**ADDENDUM NO. 2 TO
WILLOW ROAD EXTENSION PHASE 2
& HIGHWAY 101 INTERCHANGE
NIPOMO, CALIFORNIA
CONTRACT NO. 300129 / 300142
FEDERAL NO. FHWA Q101(189)**

Certain revisions are hereby incorporated into the Contract Documents for the subject project. These revisions are as follows:

The Project Plans are hereby amended as follows:

DOUBLE GATE DETAIL
(SUPERSEDES DETAIL SHOWN ON SHEET C-10)

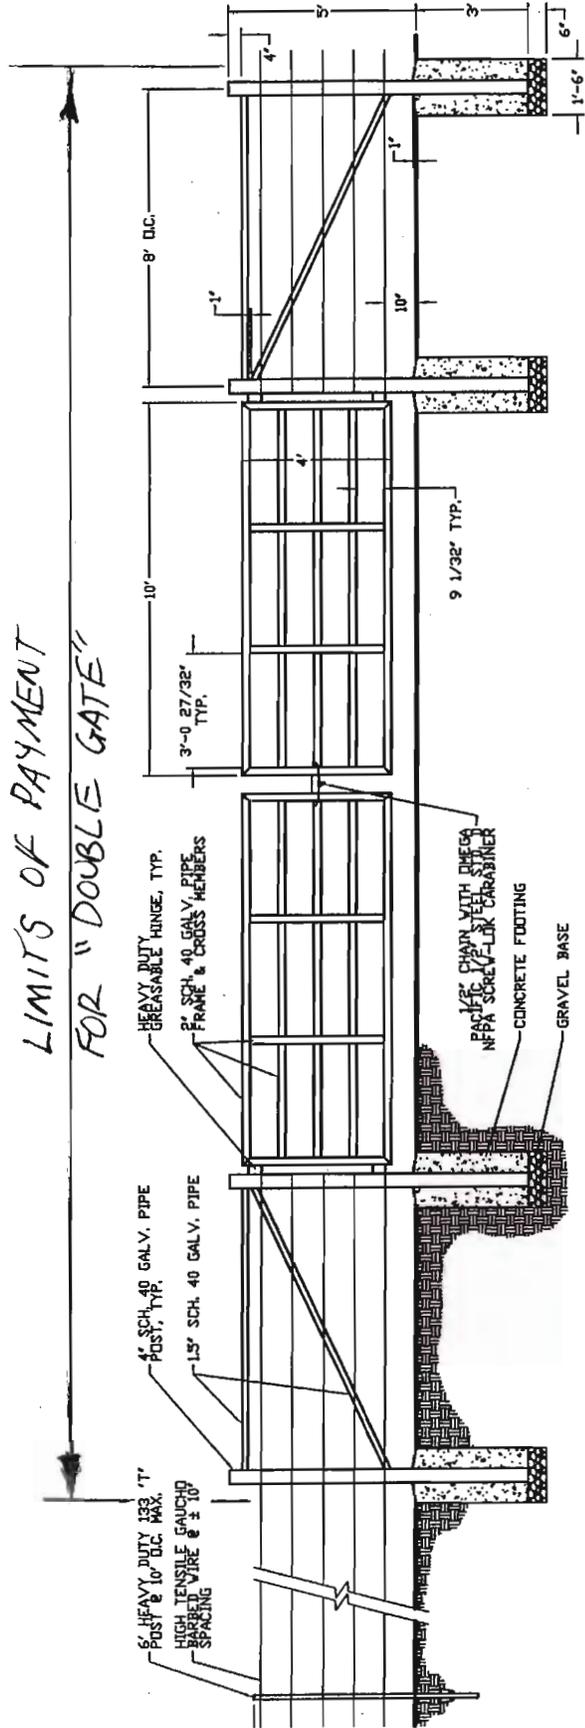
Double gates shall conform to the detail titled "Steel Gate at Road Crossing" attached to this addendum. The Contractor shall prepare shop drawings for fabrication and construction of the double gate assembly shown in attached detail. Shop drawings shall be reviewed and approved by the Engineer prior to construction.

"DOUBLE GATE" will be paid for by the unit in the manner specified in Section 80, "Fences," of the Standard Specifications. Limits of payment for the double gate assembly shall be as shown on the detail titled "Steel Gate at Road Crossing" attached to this addendum. Payment for "DOUBLE GATE" shall include preparation of shop drawings for the double gate assemblies and all appurtenant work and materials for designing, fabricating and installing the double gate assemblies in accordance with the attached detail, at the locations shown on the plans, as specified in the Standard Specifications, these Special Provisions, and as directed by the Engineer.

- 1) The attached details update the corresponding details shown on following contract plan sheets: **C-10 and C-11A.**
